<b>Title - Sujet</b> Réfection brise-lames nord	
<b>Solicitation No. - N° de l'invitation</b> EE517-192500/A	<b>Amendment No. - N° modif.</b> 003
<b>Client Reference No. - N° de référence du client</b>	<b>Date</b> 2019-04-05
<b>GETS Reference No. - N° de référence de SEAG</b> PW-\$QCM-017-17638	
<b>File No. - N° de dossier</b> QCM-8-41238 (017)	<b>CCC No./N° CCC - FMS No./N° VME</b>
<b>Solicitation Closes - L'invitation prend fin</b> <b>at - à 02:00 PM</b> <b>on - le 2019-04-16</b>	
<b>F.O.B. - F.A.B.</b> <b>Plant-Usine:</b> <input type="checkbox"/> <b>Destination:</b> <input checked="" type="checkbox"/> <b>Other-Autre:</b> <input type="checkbox"/>	
<b>Address Enquiries to: - Adresser toutes questions à:</b> Cloutier, Annabelle	<b>Buyer Id - Id de l'acheteur</b> qcm017
<b>Telephone No. - N° de téléphone</b> (418) 649-2768 ( )	<b>FAX No. - N° de FAX</b> (418) 648-2209
<b>Destination - of Goods, Services, and Construction:</b> <b>Destination - des biens, services et construction:</b>

## Repair of northern breakwater – Port of Gros Cacouna Port of Gros Cacouna, Cacouna

### Amendment 003

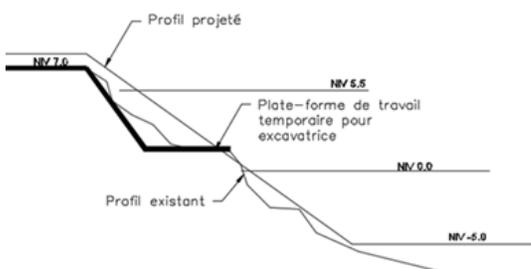
Is it acceptable to lower a portion of the existing slope to provide a lowered work platform for work that extends to the - 5.0m level? See below a typical sketch.

**Answer.** It is acceptable to build temporary work platforms in the slopes. Note that the existing stone work can be made of larger size stones.
